BWROG-09020
March 20, 2009

SUBJECT: BWROG Response to NRC Requests for Additional Information (RAIs) on GEH BWROG Topical Reports NEDC-33347P Revision 0 (Proprietary Version) and NEDO-33347 Revision 0 (Non-Proprietary Version), "Containment Overpressure Credit for Net Positive Suction Head (NPSH)"

Final BWROG Responses To NRC Requests For Additional Information
Regarding Containment Overpressure Credit For NPSH (NEDO-33347)

Figure 1: Flow diagram for statistical containment analysis for LOCA, ATWS, SBO, and Appendix R events

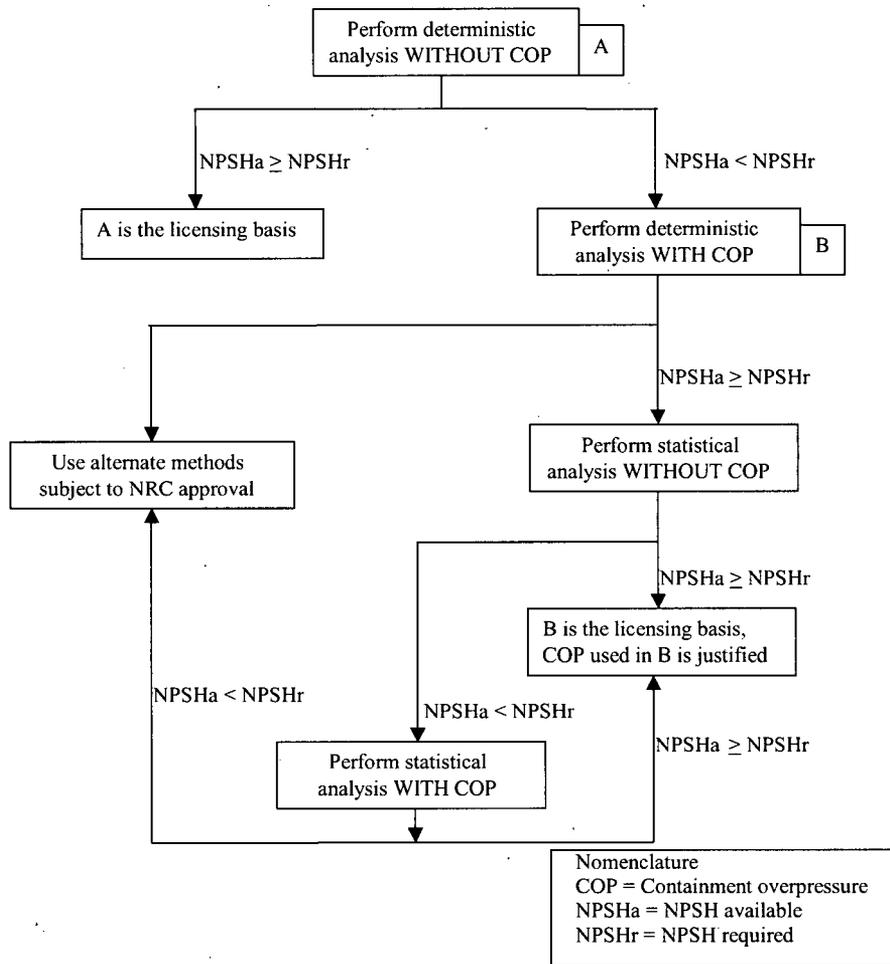
20. Section 4.3: The TR states that the proposed method for evaluation of special events will utilize nominal input values. It goes on to state that if this approach does not show that $NPSHa - NPSHr \geq 0$ then the statistical approach using mean values will be used.
- a. How is the mean determined?
 - b. If the statistical approach does not show acceptable results, what is the next step?

NRC Supplemental Comment: a. & b The LTR proposal that the deterministic analysis be the licensing basis when it yields an unacceptable result is not acceptable. The staff proposal of an acceptable process is shown in Figure 1 which applies to containment analysis for LOCA, ATWS, SBO and Appendix R events. If "statistical analysis with COP" (C in Figure 1) is used as a licensing basis, a revised analysis would not be necessary if the change in data were small.

An NRC-developed flow chart is below:

- a. The mean output statistical approach uses the Monte Carlo method to produce 59 containment analyses. The results of these analyses are utilized to produce a term called Hww. Each of the 59 containment analyses produces Hww for each time step. For each time step of the 59 analyses, the maximum Hww, mean Hww and the minimum Hww can be determined and plotted. Special event determined mean values would have a family of curves similar to the examples in Figures A-1 and A-2 of the topical report. The mean Hww term per each time step is combined with the elevation head and the head losses from the suction strainer and suction line per time step to produce a mean statistic NPSHa value.

- b. The next step if the statistical approach does not show acceptable results would be to review appendix C and D of the topical report titled “Alternate methods to containment overpressure” and “COP Credit” and implement scenario changes or plant modifications as appropriate.

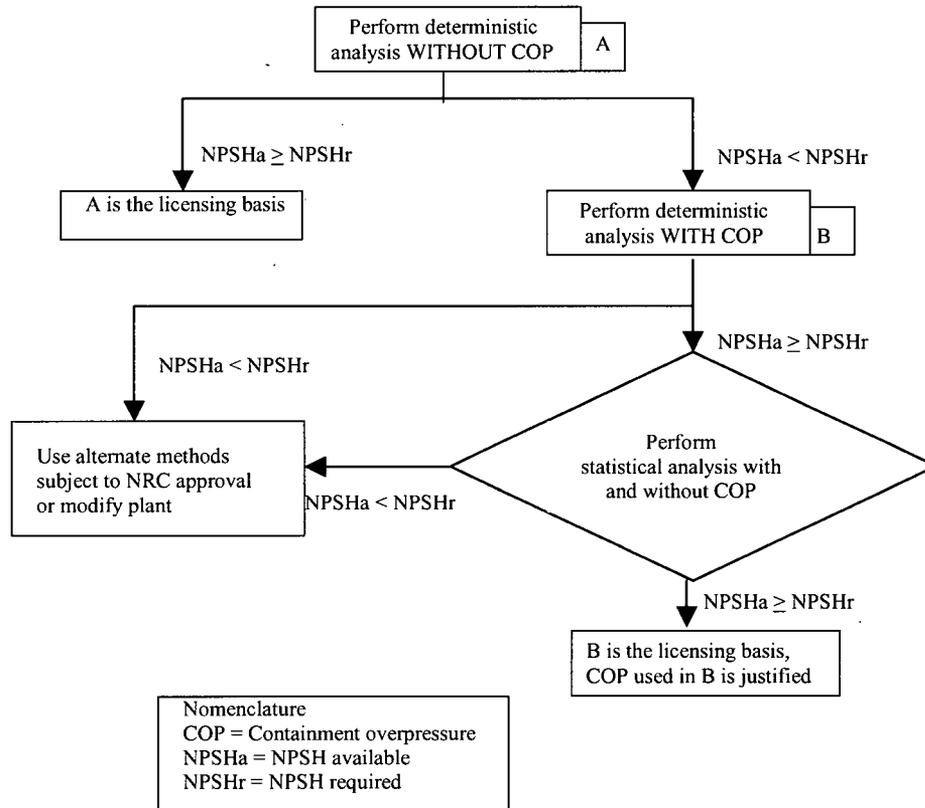
The NRC clarified the definition of “unacceptable result” to mean “NPSHa < NPSHr,” and

an acceptable result to mean “ $NPSHa > NPSHr$.” The BWROG understands that the NRC objects to retaining the deterministic licensing basis if the deterministic results are unacceptable and the corresponding statistical results are acceptable. The BWROG believes that the corresponding deterministic and statistical analyses will either both be acceptable or both unacceptable, so the situation postulated by the NRC should not arise. If it does, the licensee will need to take alternate action. The BWROG recommends the following changes to the NRC flow chart to improve clarity:
